TECHNICAL BULLETIN

Engine Oil – Viscosity/Temperature Ranges – Revisions

12-58

MODEL All 4.0 and 6.0 1995-96 MY

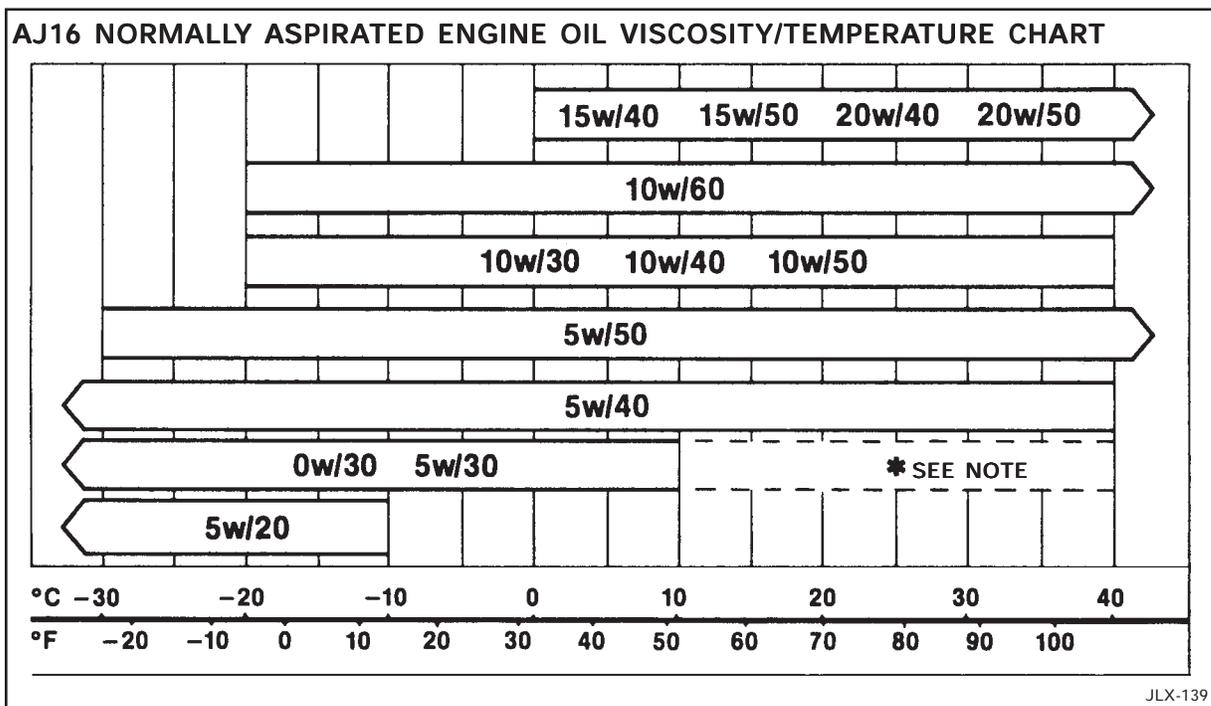
In addition, the ambient temperature range for the use of 5W/30 oils has been extended from 50°F (10°C) to 104°F (40°C) subject to certain limitations on oil specifications on AJ16 normally aspirated engines ONLY.

V12 & AJ16 SUPERCHARGED ENGINE OIL VISCOSITY/TEMPERATURE CHART

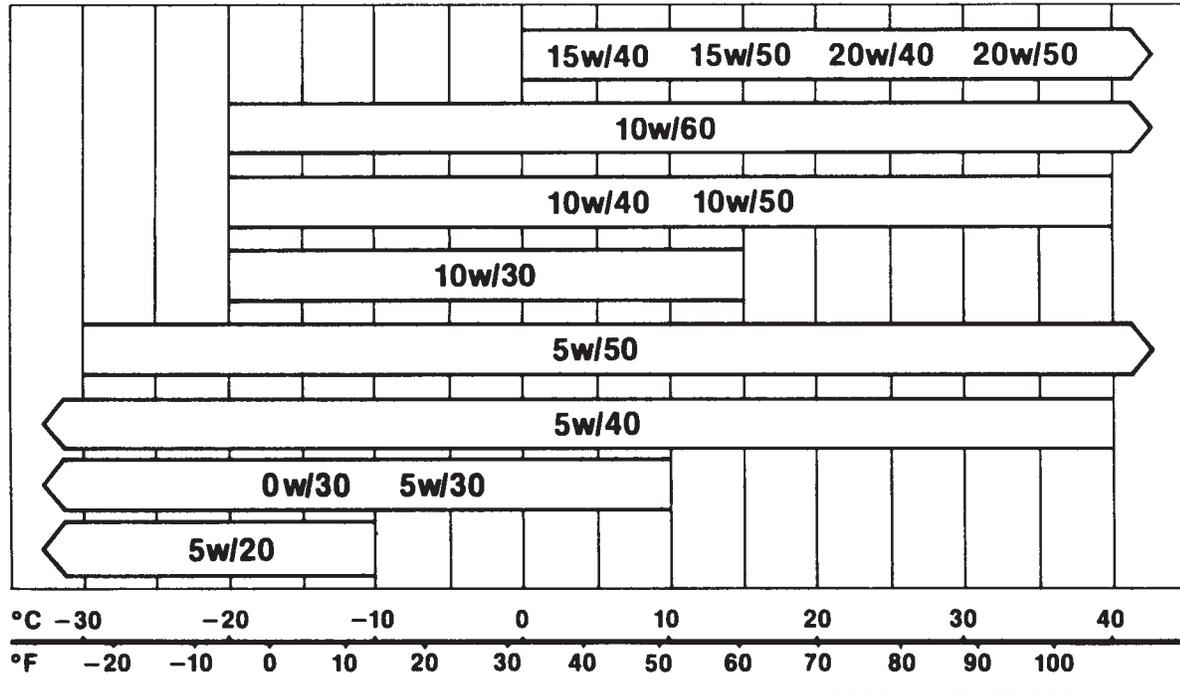
Jaguar has approved the use of grade 0W/30 low viscosity engine oils, subject to certain limitations regarding ambient temperature and oil specifications, in both V12 and AJ16 engines.

Refer to the following charts when selecting engine oils.

Fully synthetic oil can be used to top up engines containing partly synthetic 0W/30 or 5W/30 engine oil.

Partly synthetic oil **MUST NOT** be used to top up engines filled with purely synthetic oil. The engine must be topped up with purely synthetic oil only, or it will no longer qualify for operation in ambient temperatures from 50-104°F (10-40°C).
